Independent Review of the
Bowdens Silver Pty Limited
Surface Water Assessment – Updated
(WRM Water + Environment Pty Ltd
February 2022)

Figure 1 Average monthly rainfall data presented in Bowdens surface water assessment

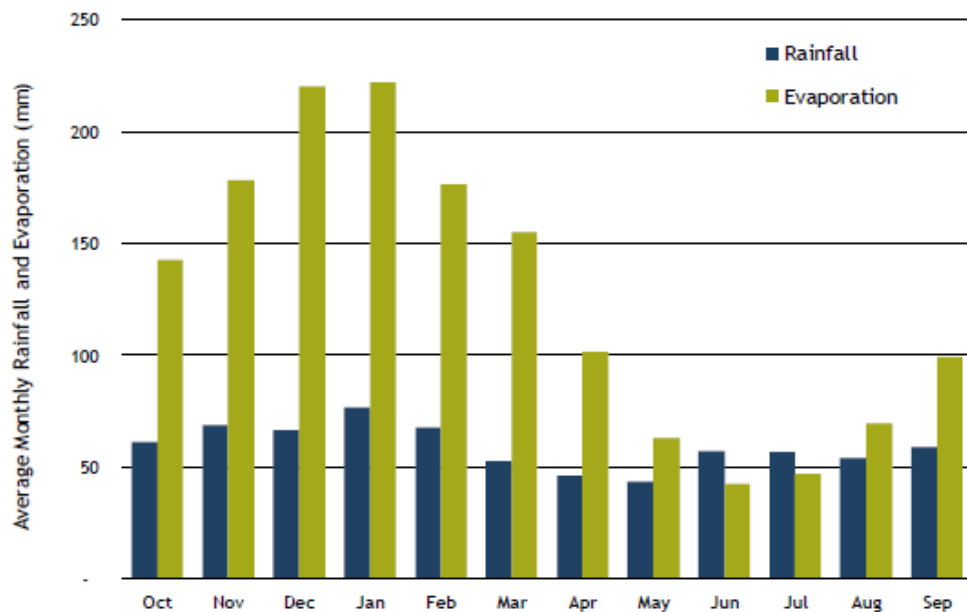
The Bowdens surface water assessment data appears to show a monthly average that exceeds 75mm over summer. This is incorrect, as evidenced by the rainfall data from Mudgee (26km west of the mine site), Rylstone (22km south of the mine site) and Lue.

Many of the other months are also too high when compared to Mudgee, Rylstone and Lue rainfall statistics from BOM. These figures need to be presented as numbers so they can be clearly understood.

Figure 5 Annual monthly rainfall data presented in Bowdens surface water assessment

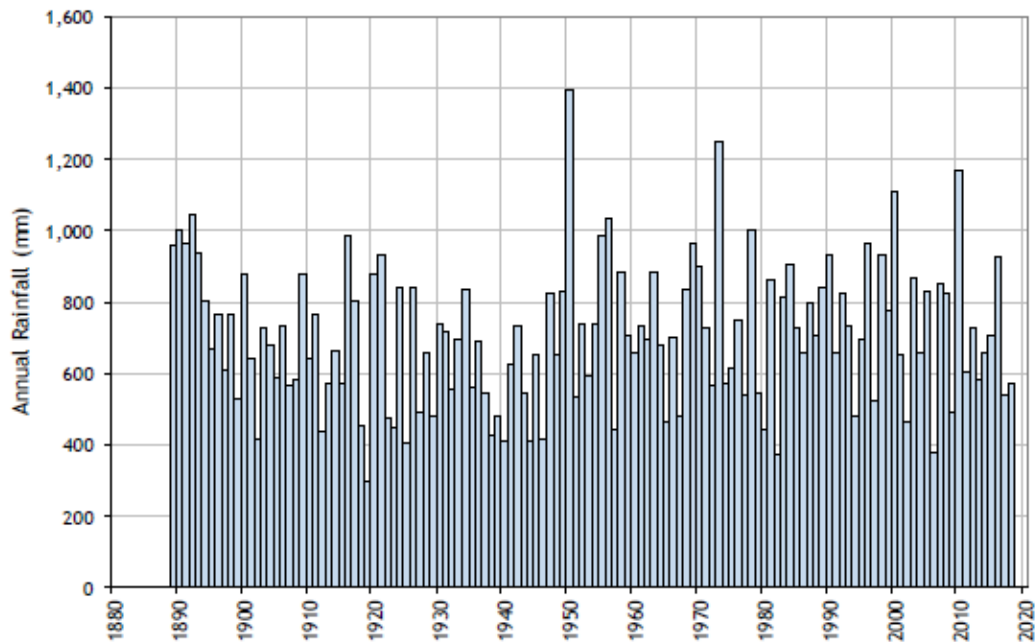
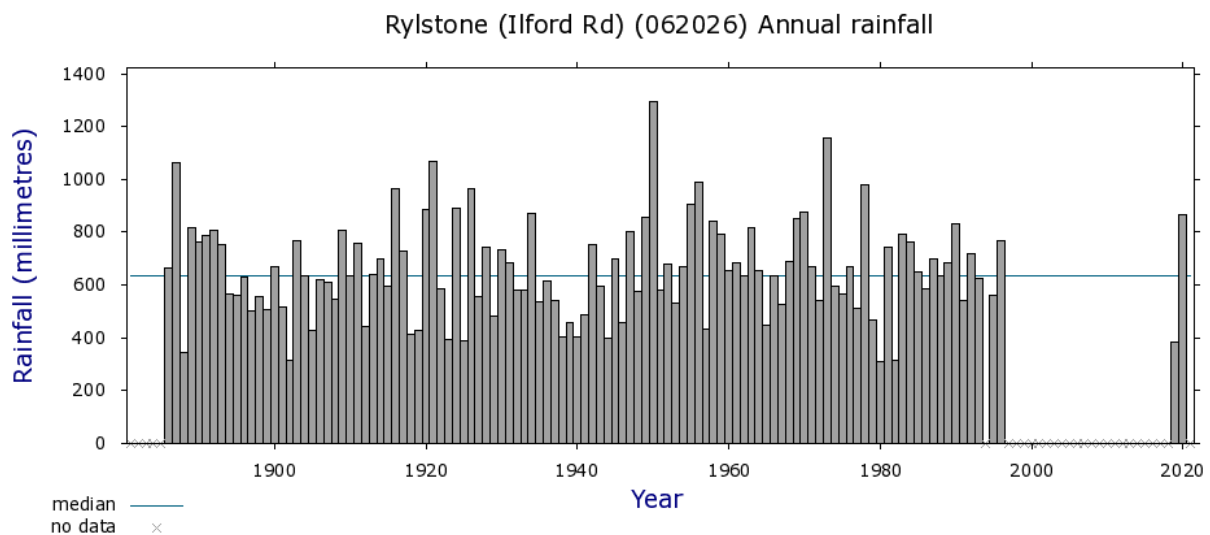
Average annual rainfall reported as 673 mm/a.

The number of very low rainfall years is clearly not reflected in the Bowdens surface water assessment annual rainfall data, which has only three years of less than 400mm. This in part seems to be a deliberate attempt to distort the data, as it has excluded 1888 and 2019, both of which are very dry years. Given that the community that will be affected by this mine have recently lived through the crippling drought which culminated in the 2019/2020 Black Summer fires, this is viewed very poorly.

WRM reported the average annual rainfall as 673 mm/a. The BOM reports the average annual rainfall for Mudgee as 671 mm/a and 654 mm/a for Rylstone. From Figure 8, it can be seen that the average annual rainfall for Lue is much less, at 614 mm/a. Given this, the estimate of 673 mm/a used by WRM for the surface water assessment is considered unrealistically high. Rather, it would be reasonable to use an estimate of 662 mm/a, being the average of the recorded rainfall for Mudgee and Rylstone. However, it should also be noted that the area in which the mine site lies is generally regarded as being within a rain shadow, with the Great Divide lying to the east and another mountain range to the west. Thus, an average annual rainfall of no more than 654 mm/a may be a more realistic estimate.

Figure 8 Rainfall cumulative distribution frequency

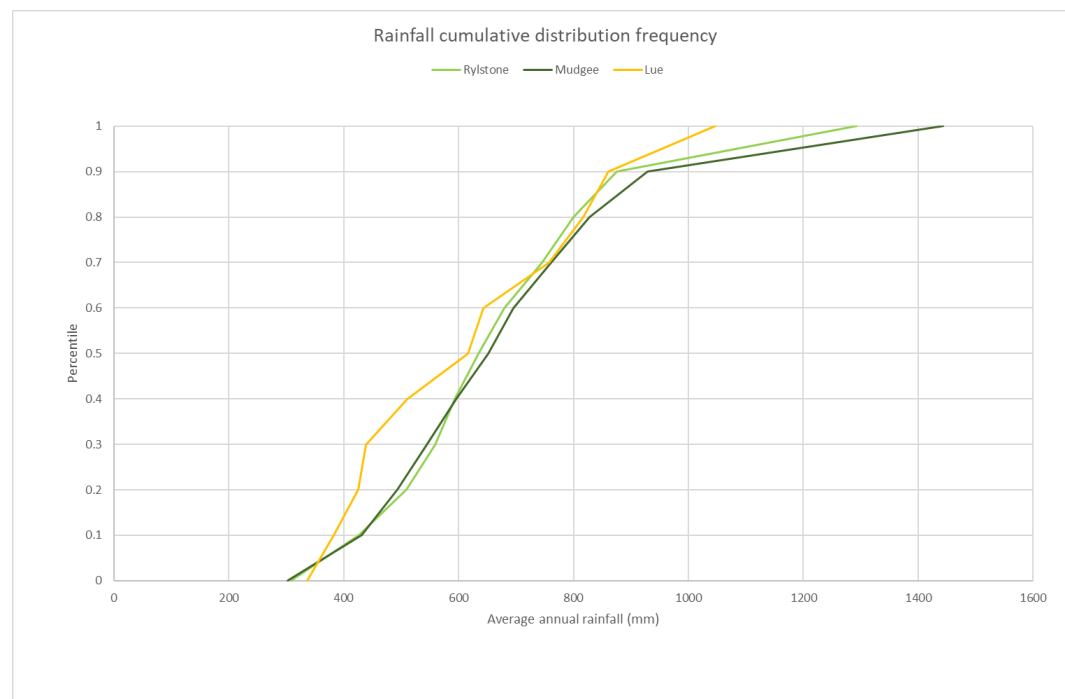
The percentiles for Mudgee, Rylstone and Lue have been calculated using BOM data and are shown in Table 5 and Figure 8. Based on the data from Mudgee and Rylstone, one in every five years, climatic conditions are akin to a semi-arid environment. The data from Lue shows that semi-arid conditions could be experienced two in every five years.

It is also noteworthy that the median for Rylstone and Mudgee is 635 and 656 mm/a respectively, and the 20th percentile is 509mm/a and 494 mm/a respectively. The 20th percentile for Lue is 425.7mm and the 40th percentile is 510.5mm. The point of this is that in Australia, a semi-arid climate is one where average rainfall is between 250mm and 500mm per year⁹. The analysis here shows that one in every five years, the climatic conditions for Rylstone and Mudgee are semi-arid. The data from Lue, adjacent to the proposed mine site, shows that semi-arid conditions could be experienced two in every five years. This means that any loss of available water in these years severely impacts the land, and the people, plants and animals trying to survive on it.

Figure 10 Regional Biophysical Strategic Agricultural Land (BSAL)

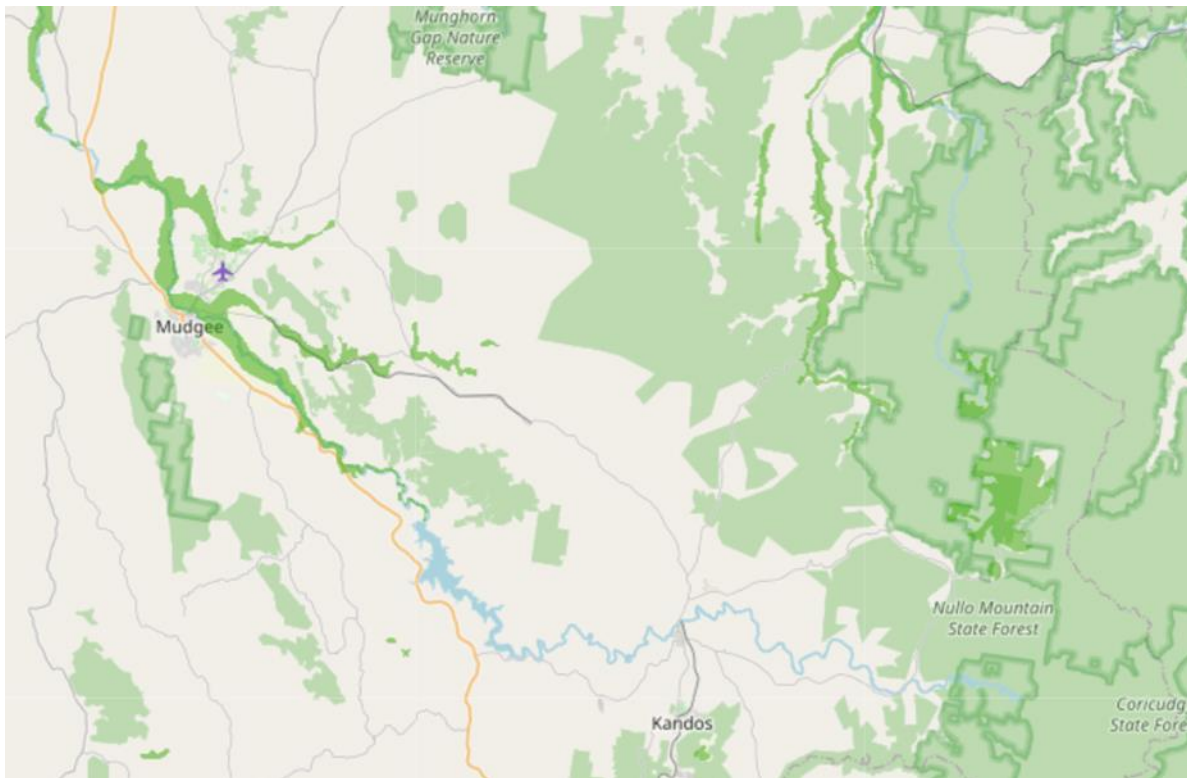
Downstream of the proposed mine site, there is BSAL present (Figure 10). The surface water assessment has not considered the impacts of using water from within Bowdens' holdings on this land.

Given the climate variability experienced in this country, the water resources are a critical part of this equation. As DPIE itself says (above), BSAL is that land which has the best quality soil and water resources and plays a sustaining role in the State's \$12billion agricultural industry.

As has been demonstrated in the analysis in this paper, the catchment in which the mine site is proposed has a high variability in rainfall and frequently experiences dry years. The water that supports the BSAL land moves through the upstream catchment and then is available to support agriculture in the mapped areas. Any mining within the supporting catchments threatens the water resource in the BSAL areas. The proposed mine will interrupt both groundwater and surface water flows, and as such, the BSAL area is at risk of losing the critical water which underpins its inherent value.
